COUNTY ADMINISTRATOR'S OFFICE

Re: Rosemont Mine Supplemental Information Report

Technical Memorandum

Review of Surface Water/Groundwater Relations Memoranda in the Cienega Creek Watershed

Figure 3. Probability plots with 95% confidence limits for normal and lognormal distributions.

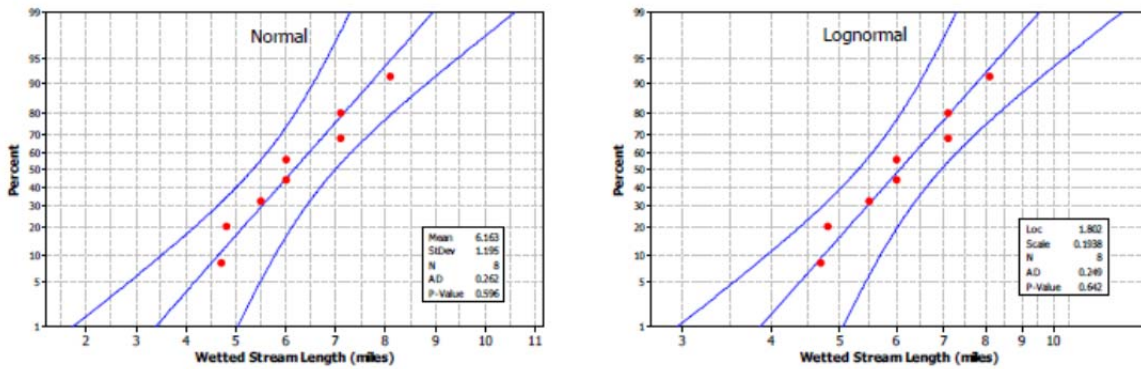
Rosemont fitted the wetted stream length data to various probability distributions so that they could use probability modeling to determine the probability of the stream being dry, or in probabilistic terms, the wetted stream length going to zero. There were just eight data points used, and the shortest wetted stream length is 4.7 miles, recorded in June 2013. Rosemont Table 12 presents results of a fit test showing that even the lowest test statistic, supposedly meaning the distribution that best fits the data, is not significant. Rosemont chose the log-normal and normal distributions because the test statistics were lowest. The following figures are from Rosemont (2014) and show the cumulative probability and the probability density for each of the chosen distributions. Their Figure 3 shows that the one percent cumulative probability is about 3.5 and 3.9 for the normal and lognormal distributions, respectively. That means that if the distributions accurately describe the wetted stream length, the return interval is 100 years for wetted stream length being less than 3.5 or 3.9 miles (probability of 0.01 corresponds to return interval if the wetted stream length can be considered an annual value, in this case the shortest length for the year). Rosemont Figure 4 shows that the probability of a wetted stream length being less than about 2.5 miles is much less than 1%.

It is apparent that Rosemont used probability distributions far beyond their population of data (the population being the measured wetted stream lengths). **No results using such a distribution can be considered credible because it is far beyond the realm of model calibration.**

Figure 7. Correlation between flow and wetted stream length as a function of averaging period.

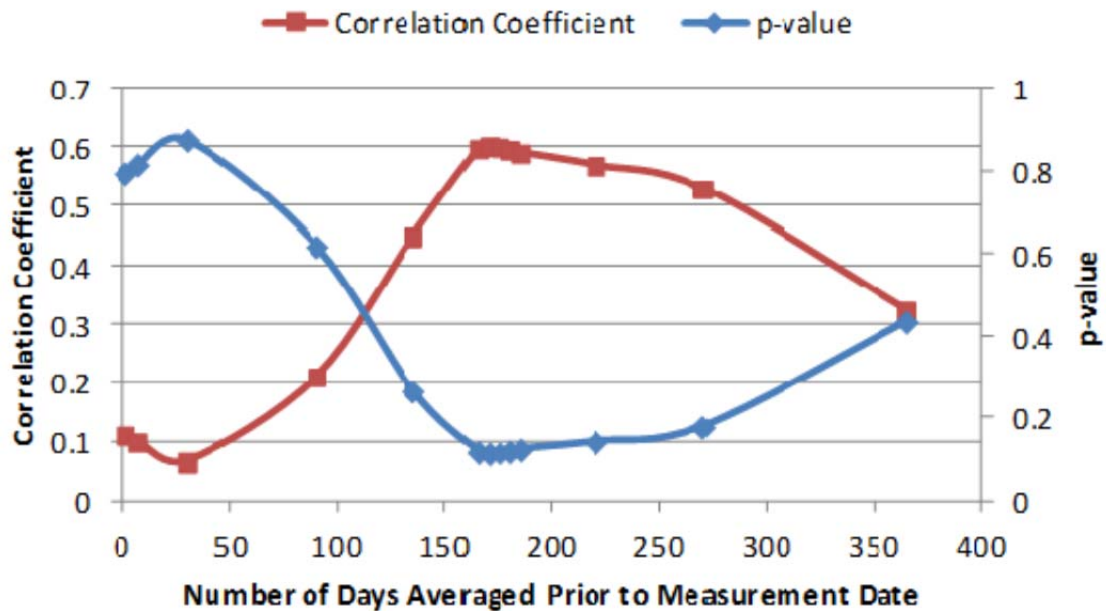
As part of their consideration of the Tetra-Tech model of decreased streamflow, Rosemont correlated flow of various metrics with the wetted stream length. As the following figure, snipped from Rosemont (2014) shows, the average of the gaged flow for the previous 170 days correlated the best, meaning that wetted stream length depends most on the previous six months climatology rather than short-term flows. The correlation was non-parametric and the linear regression completed to obtain 4.35 miles of stream length lost for a 1 cfs change in flow is inappropriate because linear regression assumes normality. **The R^2 is low and non-significant, therefore it is inappropriate and incorrect to claim that a 0.08 cfs predicted reduction in flow can translate into a 0.334 mile reduction in wetted stream length.** Additionally their Table 11 shows that the range in wetted stream length is from 4.7 to 8.1

miles which is a significant scatter in their regression (there is no scatter plot of the wetted stream length to any of the flow metrics). Finally, it is inappropriate because Tetra Tech’s simulated flow rate would be base flow, not the 170-day flow preceding the wetted stream length measure as used in the equation.

Simply, Rosemont used inappropriate flows and inappropriate probability distributions to estimate the probability of a dry stream. Their finding that even adding the drawdown causes essentially no chance of a dry stream is meaningless because it **is based on stretching empirical data far beyond their range**. The discussion of climate change effects simply adds one more bit of speculation to the calculation because they have to translate an annual streamflow reduction into an annual hydrograph when the effect in reality will vary through the year.
